RESPONSE TO REQUEST FOR ADDITIONAL INFORMATION

APR1400 Design Certification

Docket No. 52-046

RAI No.: 517-8670
SRP Section: 19.03 – Beyond Design Basis External Event
Application Section: 19.3
Date of RAI Issue: 08/19/2016

Figure B-1 Spent Fuel Pool Monitoring Water Level

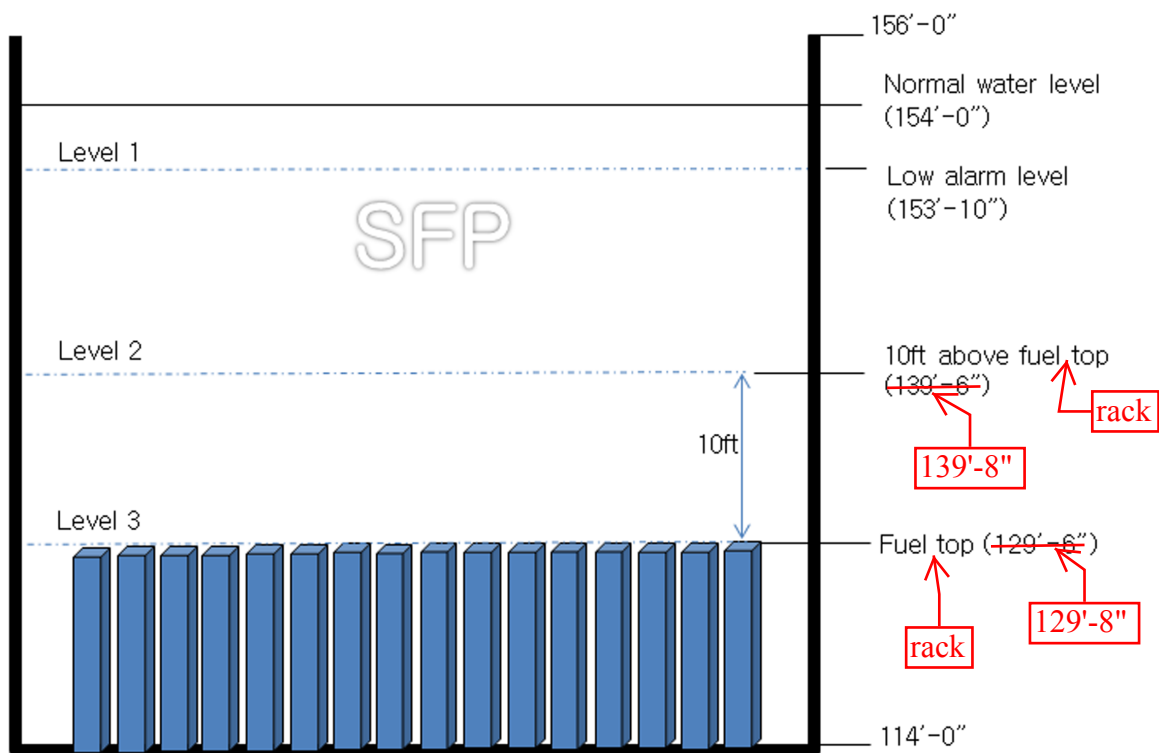
NEI 12-06, Section 3.2, "Performance Attributes," (ML12242A378) indicates that "installed equipment that is designed to be robust with respect to design basis external events is assumed to be fully available." The applicant is requested to justify/clarify the robustness of pipes that interact with the SFP that are located below the initial SFP water level assumption used in the

calculation (i.e., 154'), or to revise the assumption of the initial SFP water level and re-do the SFP analysis for BDBEEs, and revise the Technical Report and DCD accordingly.

The elevations of all pipes that penetrate the SFP are described in the response to RAI 77-7991, Question 09.01.03-1. The elevation of the SFP cleanup suction nozzle, which is located at the lowest elevation among the non-Seismic Category I pipes (Seismic Category II), is EL. 149'. Therefore, the EL. 149' is assumed as the initial water level of the SFP during BDBEEs to conservatively calculate SFP boil-off time.

- The top elevation of the Spent Fuel Rack (SFR) is changed from EL. 129'-6" to EL. 129'-8" based on the thermal hydraulic analysis which is mentioned in the response to RAI 497-8622, Question 09.01.03-6.

- Initial SFP water level is assumed at ~~normal water level~~.
- SFP inventory makeup starts when the water level reaches Level 2 defined in NEI 12-02 and shown in Figure B-1.
